## Madison Parks Division

### NOTICE OF ADDENDUM ADDENDUM 1 CONTRACT NO. 7929

PROJECT:  
**2017 PARK  
 PLAYGROUND  
 IMPROVEMENTS  
 - GROUP 3**

**LAKE EDGE PARK  
 511 PARK CT  
 MADISON, WI 53716**

SHEET NUMBER:  
**2.2**

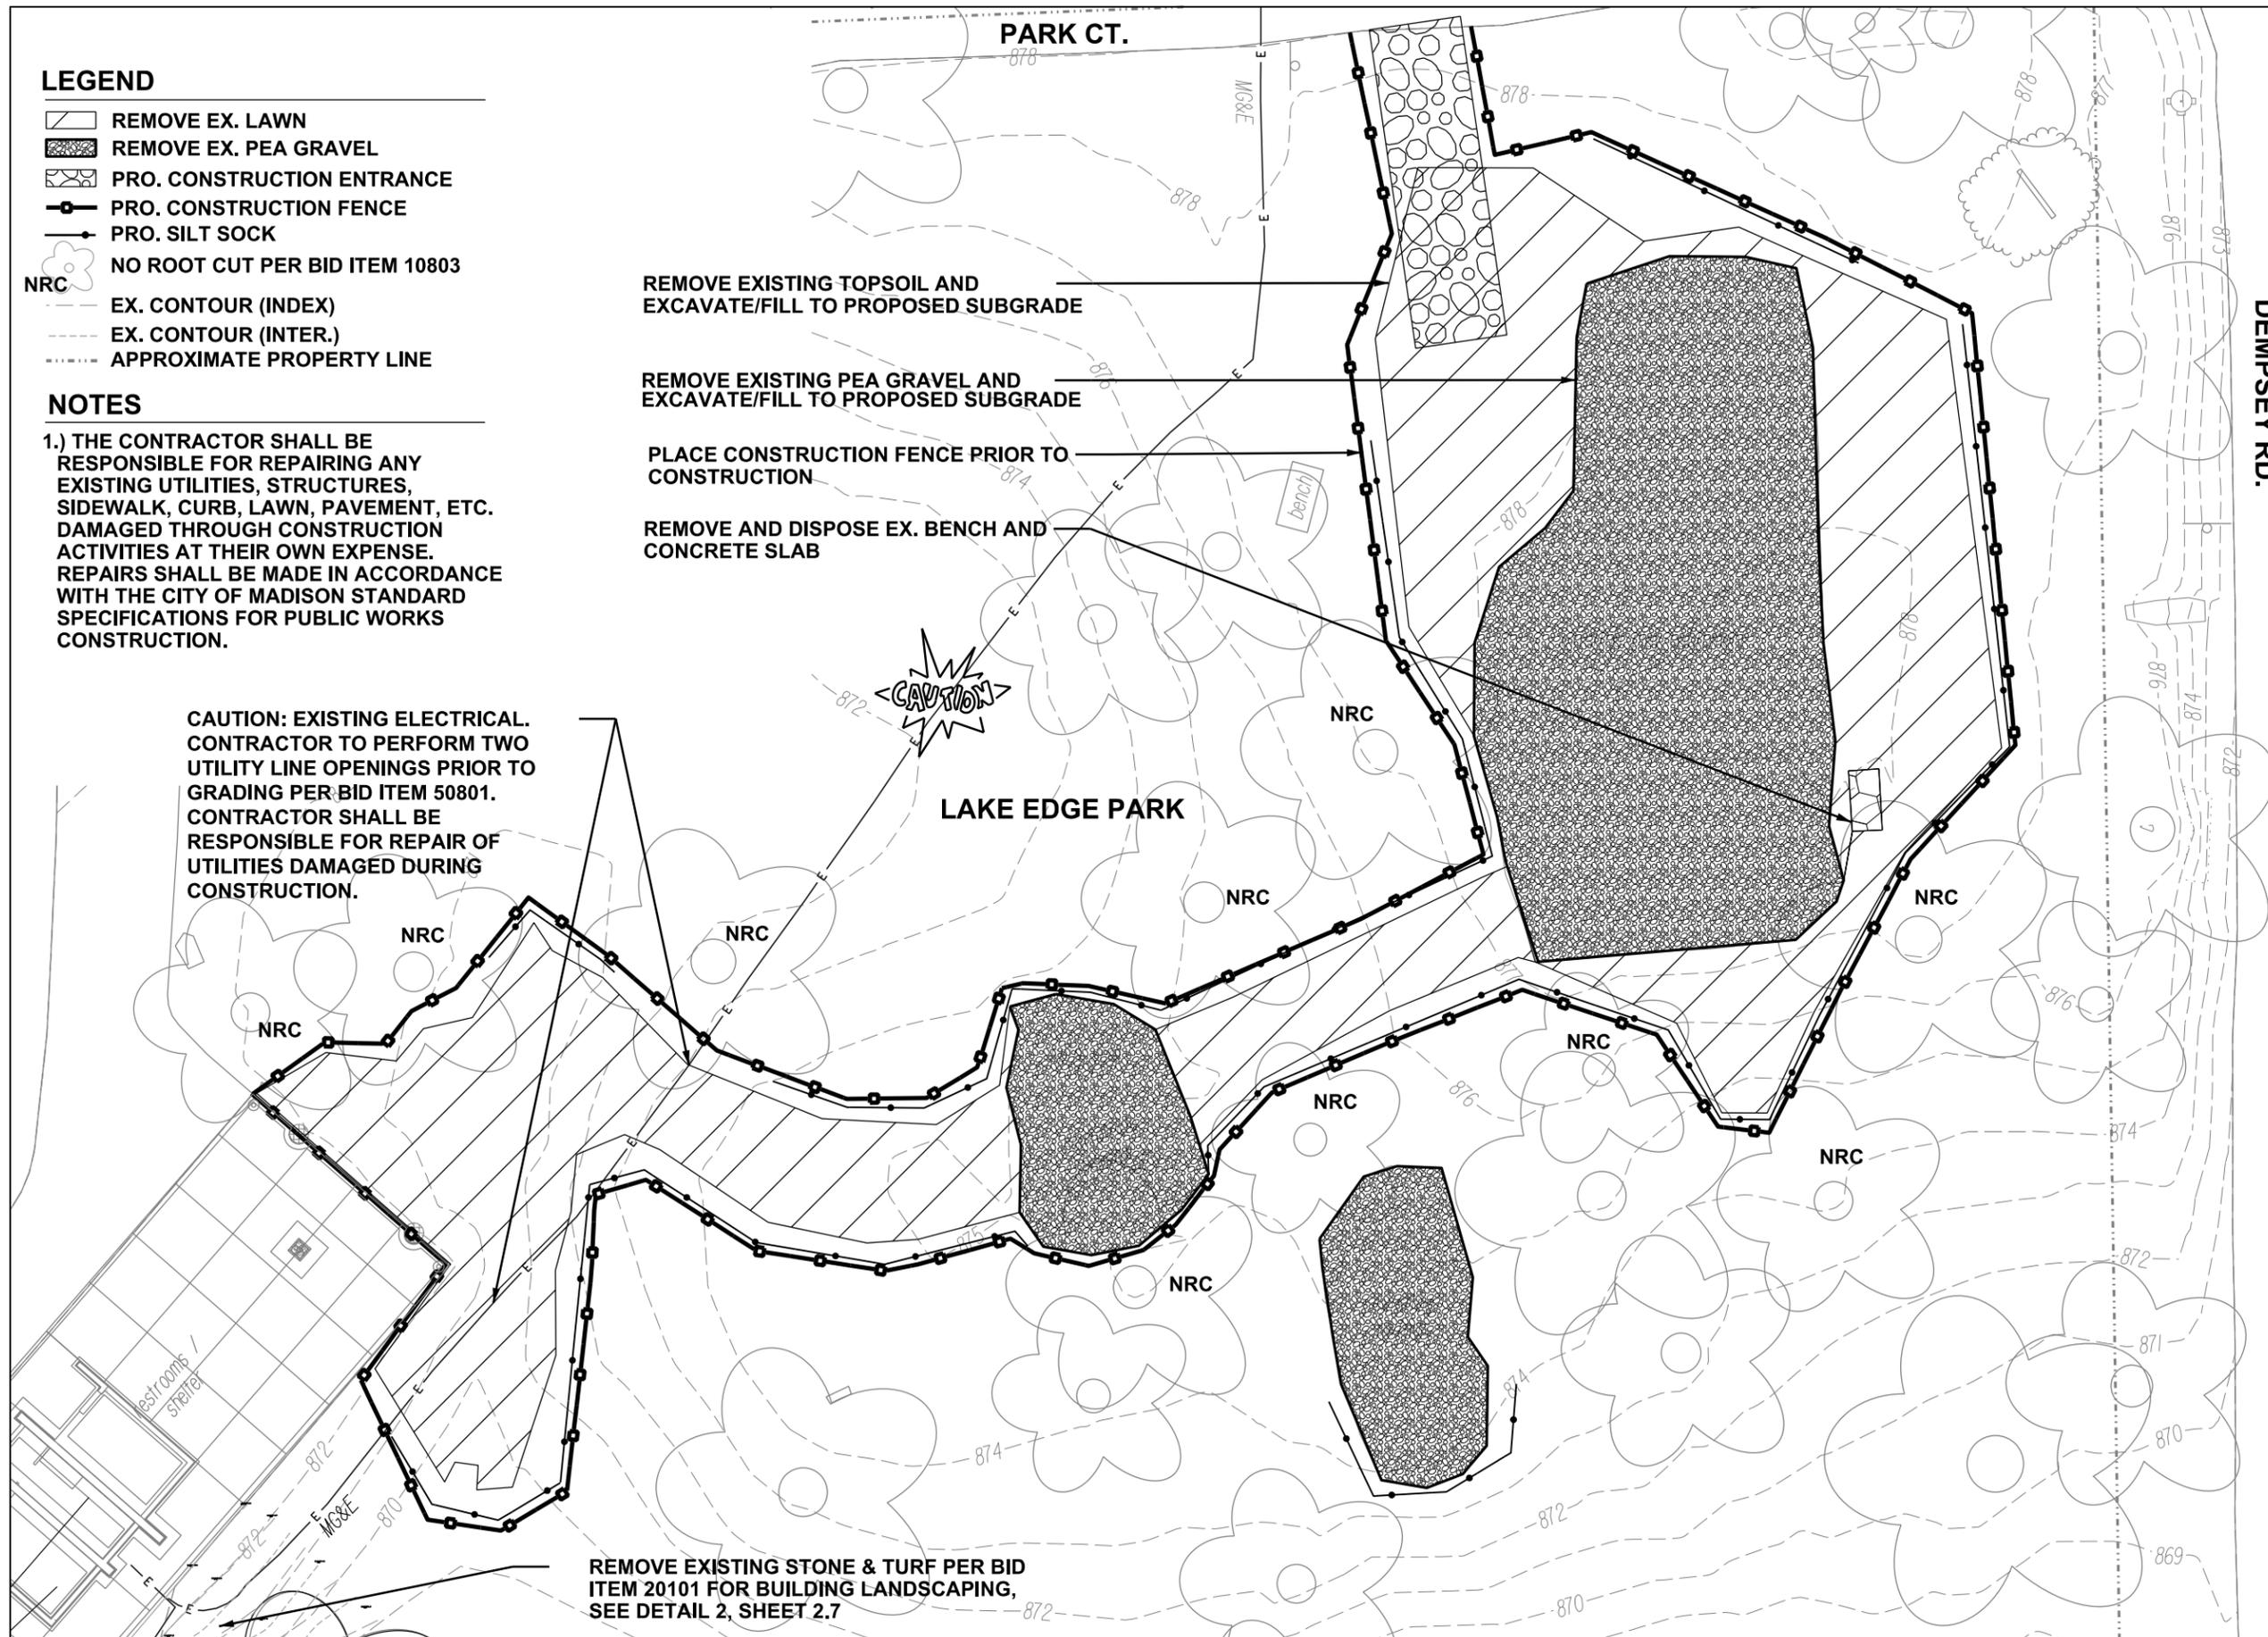
- Replace Sheets 2.1, 2.2, 2.3 and 2.7 to show additional landscaping along building foundation added to the scope of work.

REMOVE EXISTING STONE & TURF PER BID ITEM 20101 FOR BUILDING LANDSCAPING, SEE DETAIL 2, SHEET 2.7

SHEET NUMBER:  
**2.7**

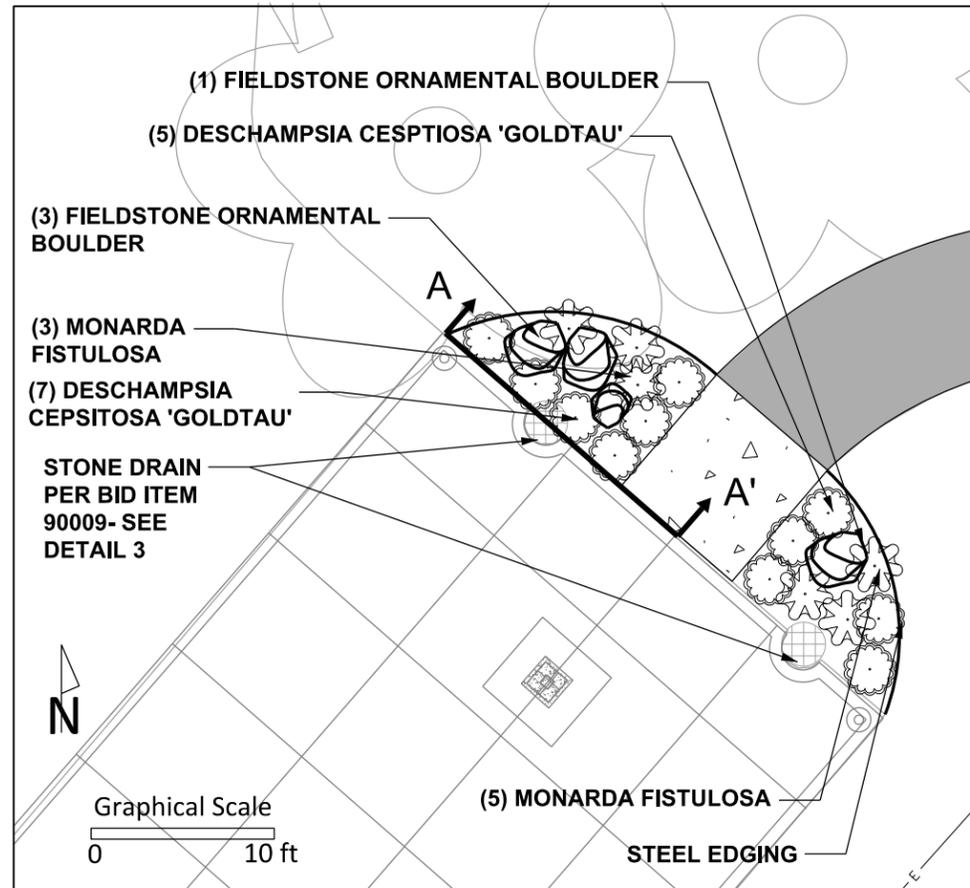
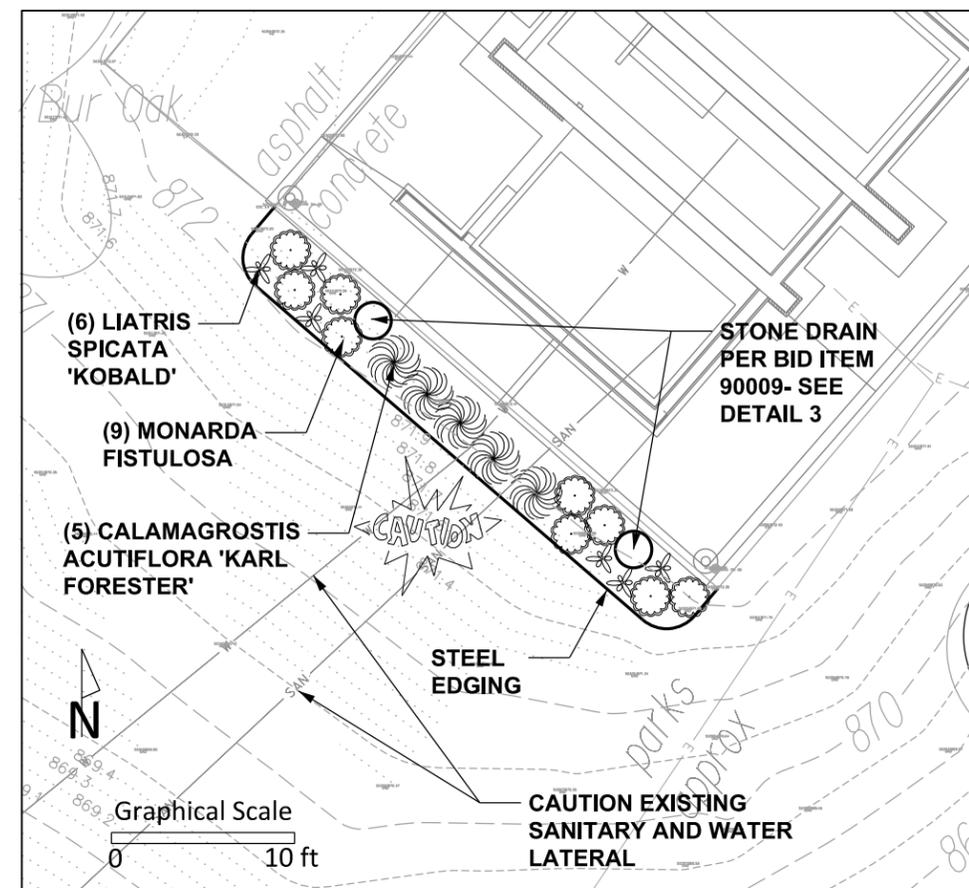
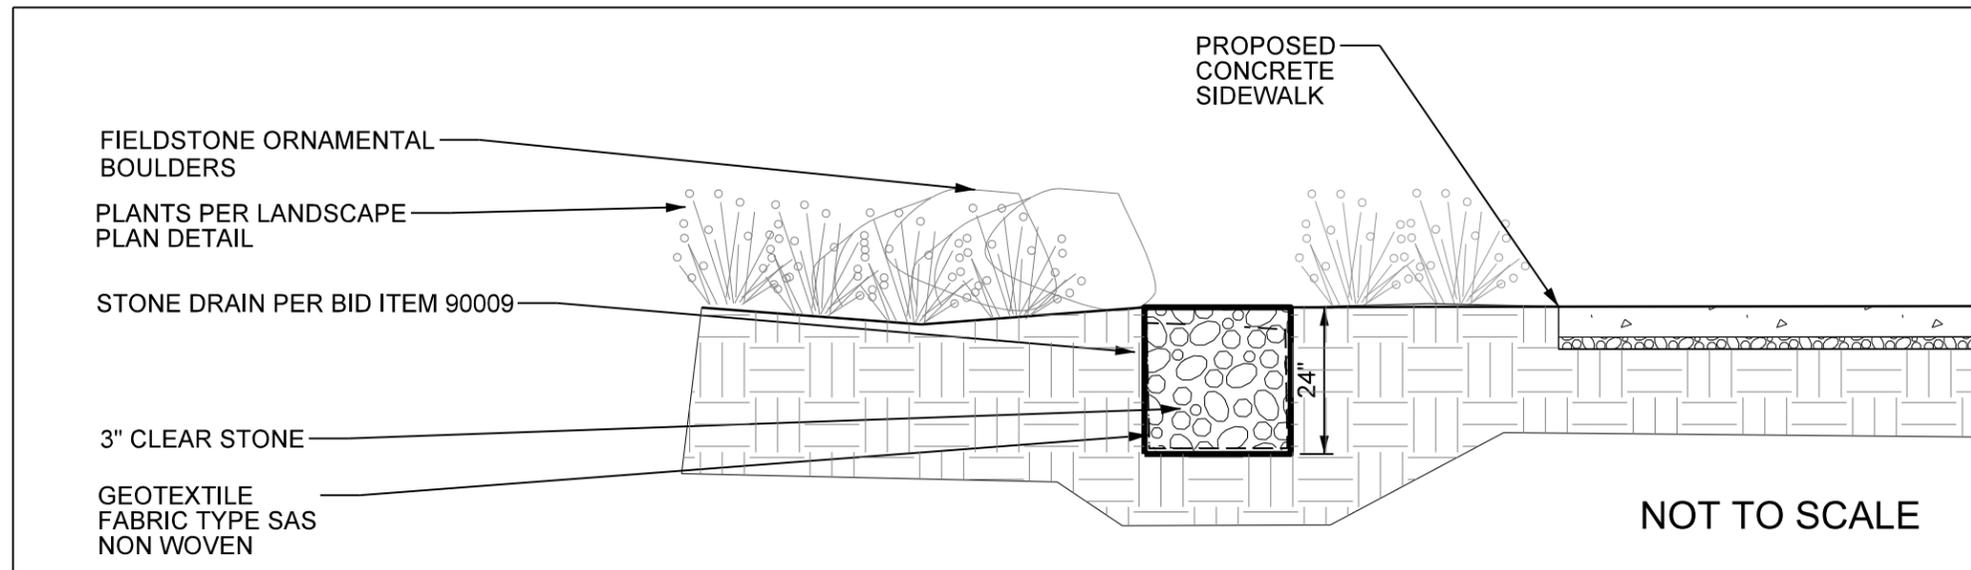
This bid item includes installation of 4 landscape beds including steel edging, 1 ½” decorative landscape stone, and 40 perennials and grasses at Lake Edge Park as shown on Sheet 2.7. Planting as part of this contract shall be completed per Article 209 – Trees, Shrubs, Perennials and Grasses of the current City of Madison Standard Specifications for Public Works Construction and as outlined in these Special Provisions.
